State of Oregon Department of Environmental Quality

Written Comments

Willamette Subbasins TMDL amendment to include Willamette mainstem and major tributaries

This document is a compilation of written comments received during the public comment period for the Willamette Subbasins TMDL amendment to include the Willamette mainstem and major tributaries.

Figure 1 2015 ETLs and TMDL WLAs

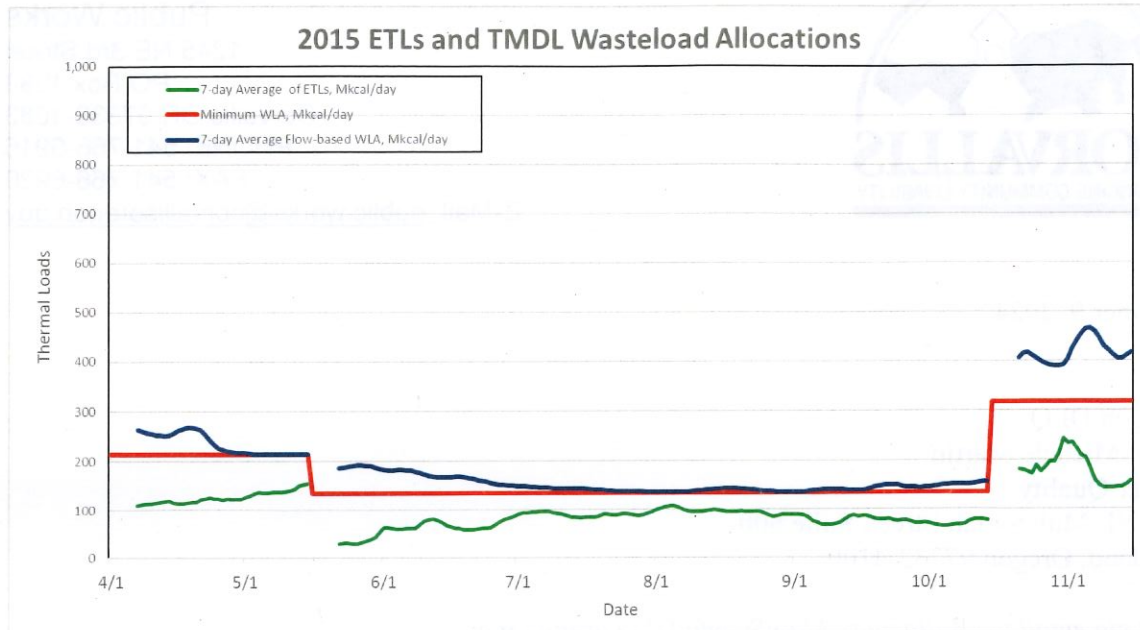
The TMDL assessment shows the discharge would be able to meet the draft WLAs based on 2014-2023 data provided to DEQ as part of this assessment; however, there is limited cushion between current thermal loads and the flow based TMDL WLAs during the summer months. The difference was particularly noticeable in 2015 and 2021, characterized by warm, dry spring and summer months (see Figure 1 and Figure 2). Both figures present the 7-day average Excess Thermal Load (ETL), the minimum (i.e., 7Q10-based) WLAs, and the flow-based WLAs for 2015 and 2021.

The cushion (i.e., the difference between the minimum WLAs and the ETLs) was as low as 29 Mkcal/day in 2015 and 15 Mkcal/day in 2021 during the summer months. These allocations suggest that the Corvallis STP facility may be unable to accommodate flow increases and thermal loads associated with near-term growth in the service area.
